ADDENDUM NO. 01

SYRACUSE HANCOCK INTERNATIONAL AIRPORT

RECONFIGURE TAXIWAYS C, F, B, E, AND G

June 6, 2018

CONSTRUCTION SAFETY & PHASING PLAN (SHEET 1 OF 4)

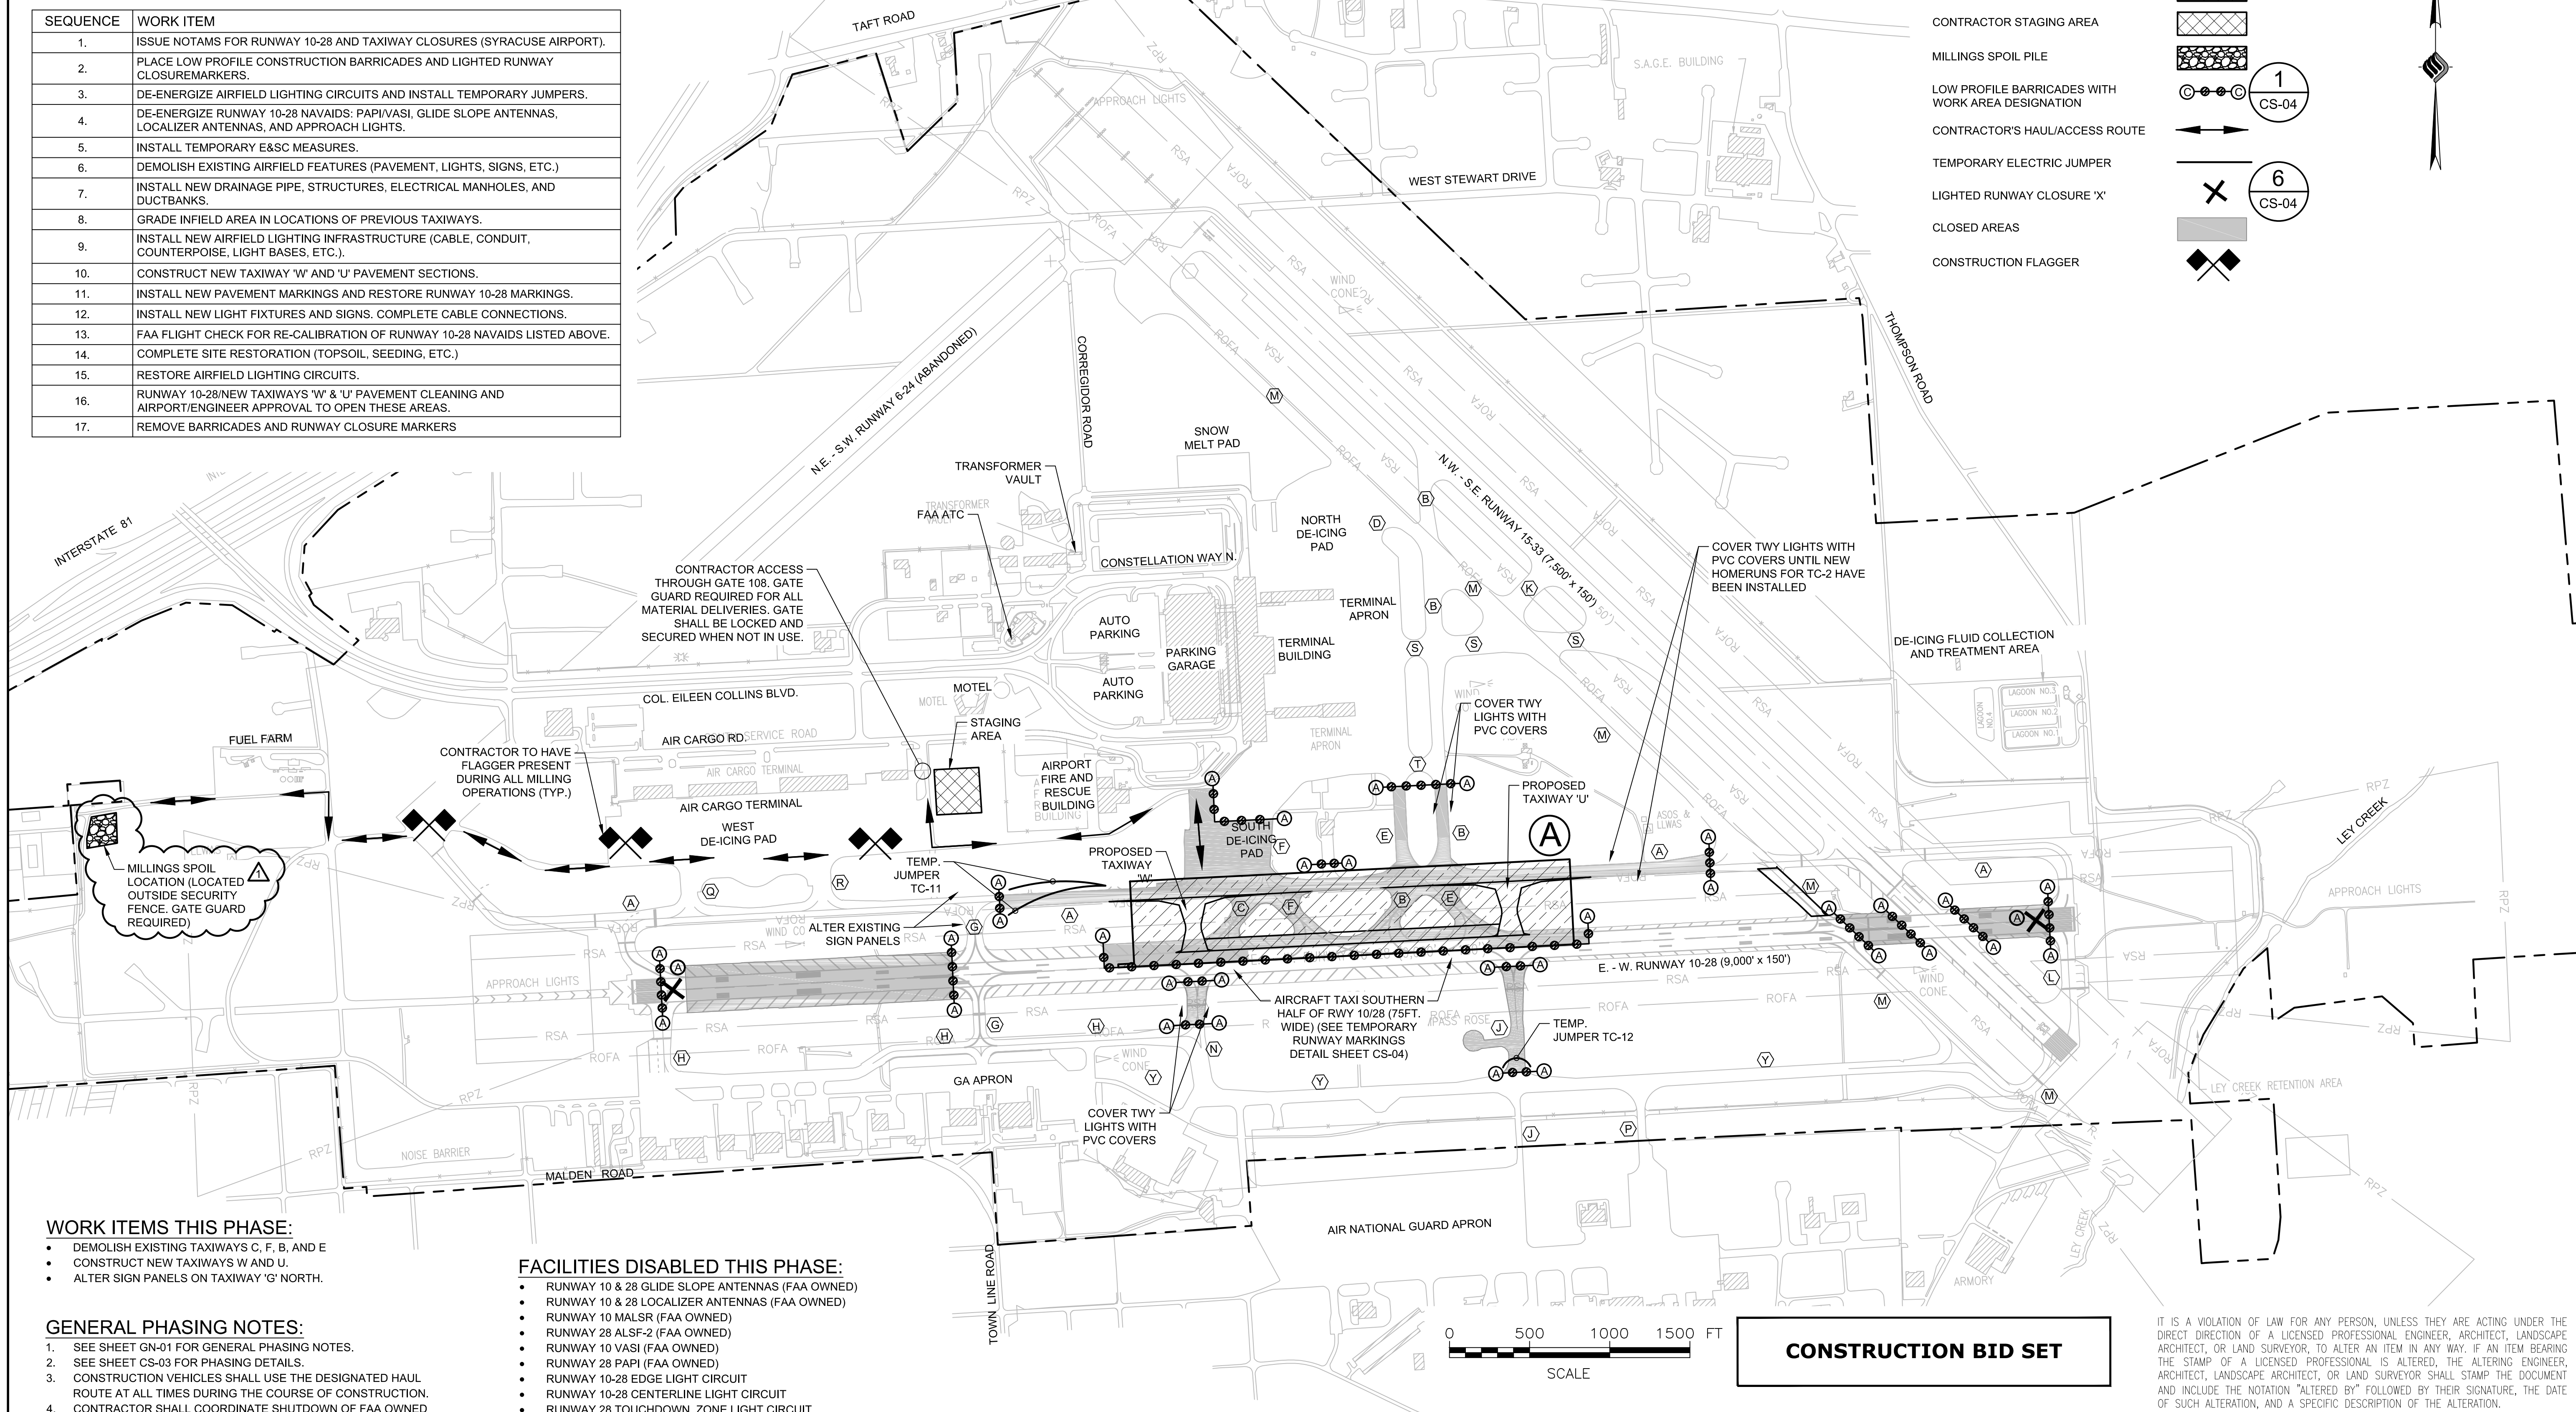
- i. Added note to clarify location of milling stockpile. Stockpile is located outside of the airport security fence and will require a gate guard during hauling operations.

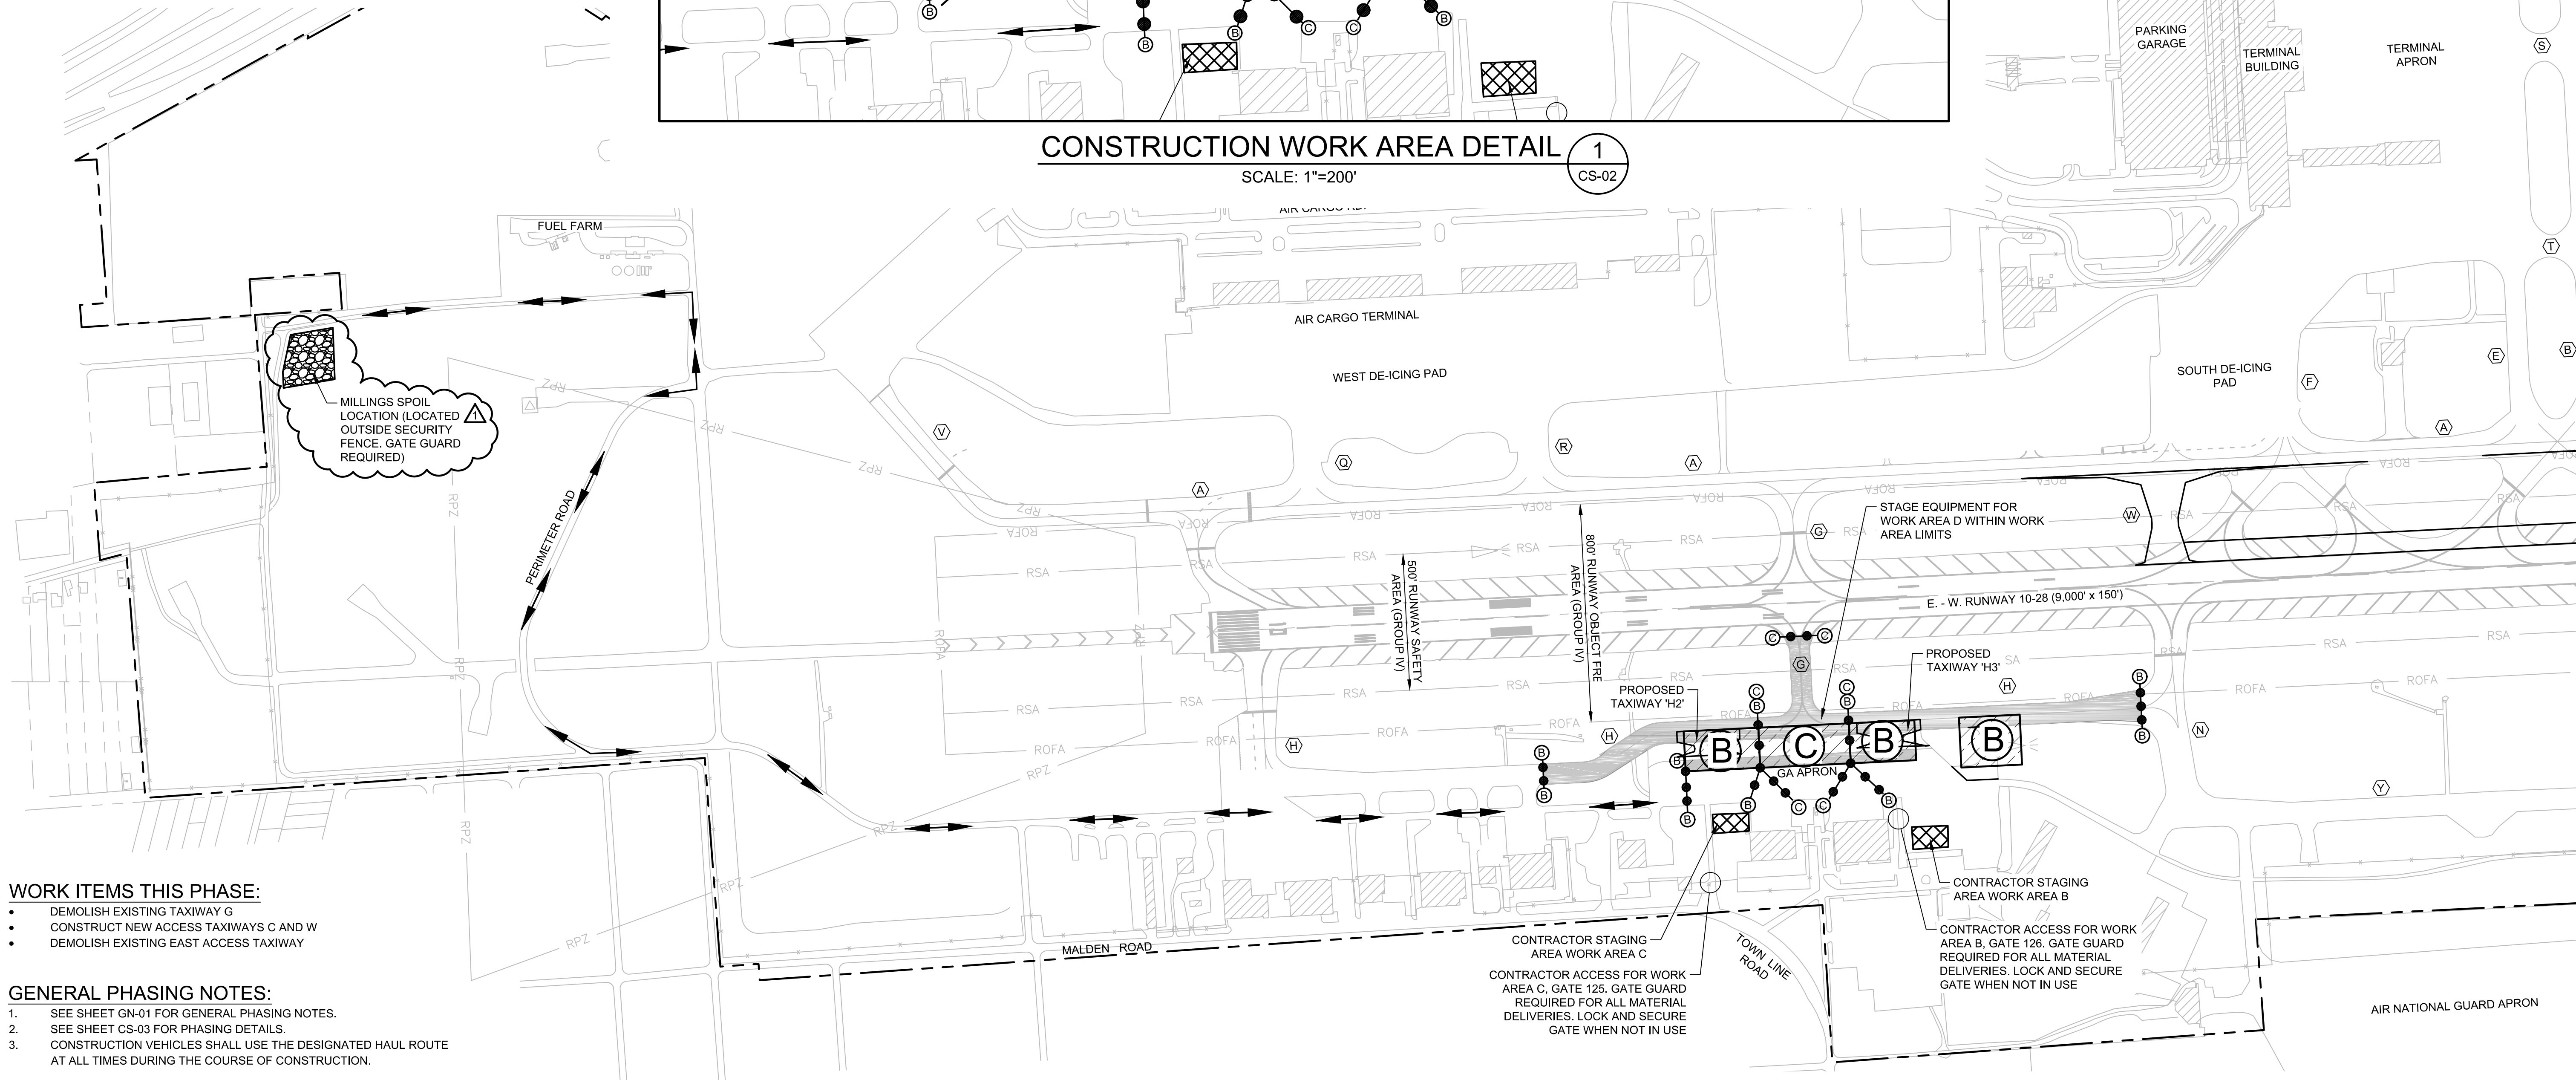
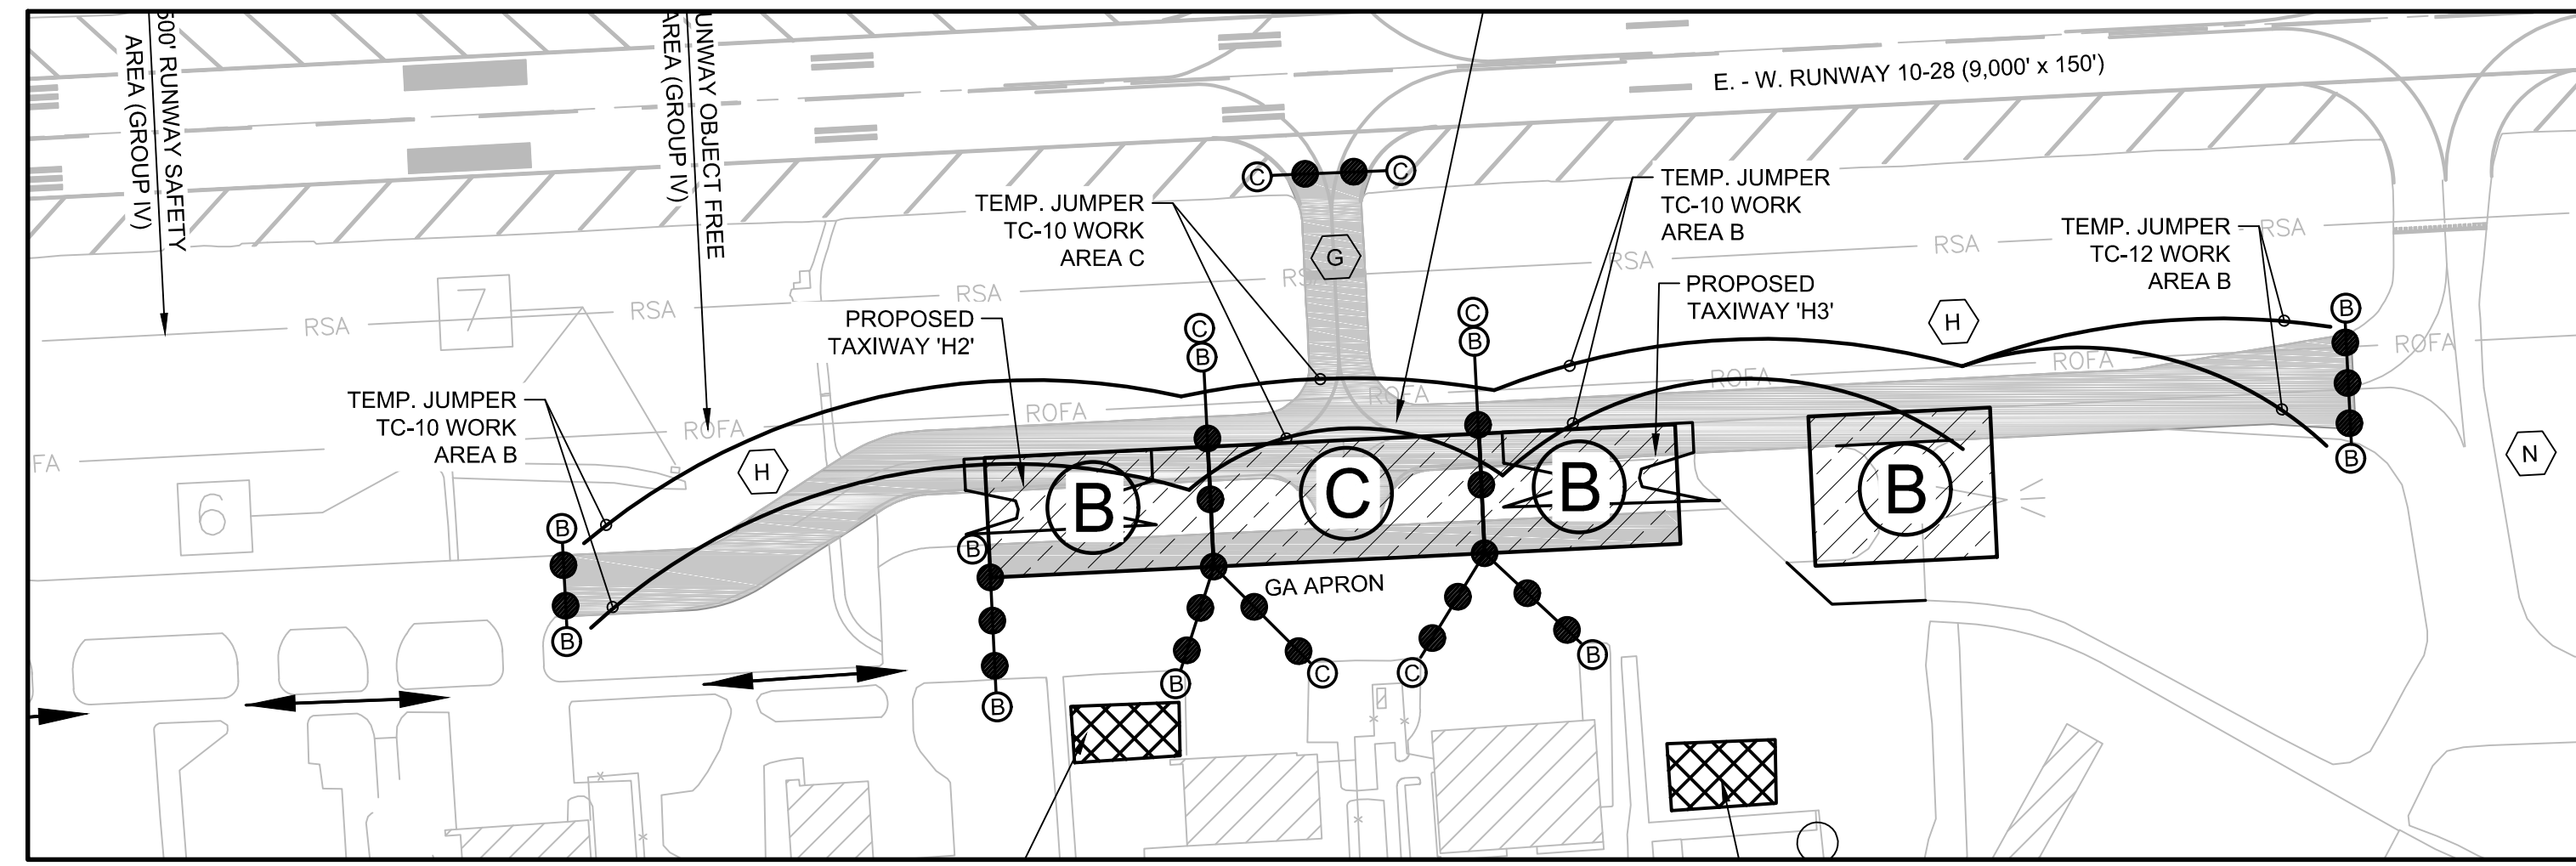
- c. CS-02 CONSTRUCTION SAFETY & PHASING PLAN (SHEET 2 OF 4)
 - i. Added note to clarify location of milling stockpile. Stockpile is located outside of the airport security fence and will require a gate guard during hauling operations.
